# **VI COLLINA MULTIFAMILY**

**2401 E. OLTORF ST.,  
AUSTIN, TX 78741  
SP-2019-0529C.SH**

*Pamela Abee-Taulli*

## VARIANCE REQUESTS

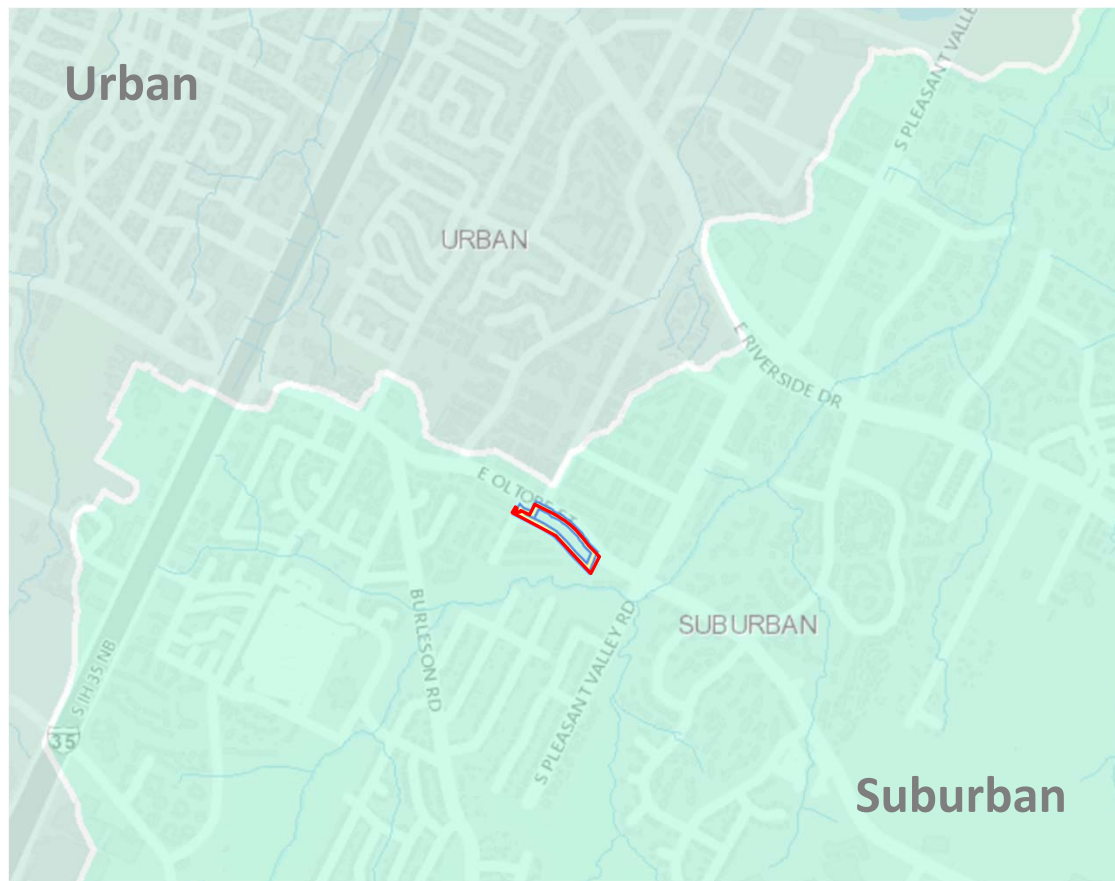
The scattered distribution of the steeper slopes, makes it impossible to develop a project of a scope appropriate to this location without variances from code.
